**City of Sweet Home**

Staff Report Presented to the Planning Commission

REQUEST: The applicant is requesting to subdivide an approximately 193,625 square foot property into 18 lots. The subject property is to the west of 45th Avenue and is identified by 1070 45th Avenue and Linn County Tax Assessor's Map No. 13S01E33AC Tax Lot 2600. Lots would range in size from 8,000 square feet to 11,697 square feet. All lots would be eligible to be developed with single, family dwellings [SHMC 17.24.020.A]. The subject property is in the Residential Low Density (R-1) Zone.

FILE NUMBER: SD22-02

SHEET TITLE:
TENTATIVE PLAT

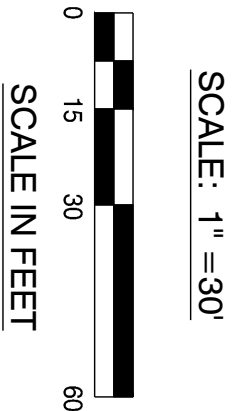
The City of Sweet Home Municipal Code states, as shown above, that City easements shall be at least 20 feet wide. Exhibit “D” indicates only a 10' STORM DRAIN EASEMENT on the south and west sides of the development. City shall not permit this reduced width.

The City of Sweet Home Municipal Code states, as shown above, that flag lots should be avoided. If in fact flag lots should be avoided, why are they being proposed for approval other than for profit of the applicant? A loop system is not needed to develop the property. Also, Exhibit 'D' reflects lot sizes including the flag pole areas which the code specifically states, "shall not be used in determining lot size." Lot sizes shall be revised accordingly.

How will the permitting agency ensure functionality of the detention area along the northerly site boundary in perpetuity so that development does not adversely impact the property and rights of others or incur loss as a result of a developer's actions? What is the purpose of (N) CONTROL MANHOLE on Exhibit H? What is the elevation of the surface water drainage feature on the south side of Long Street?

If flag lots are permitted, which should be avoided as noted above, I would highly recommend the permitting agency require the developer to reverse the layout of the lots such that the flag lots are on the south side of the development which will disburse noise pollution away from existing flag lots.
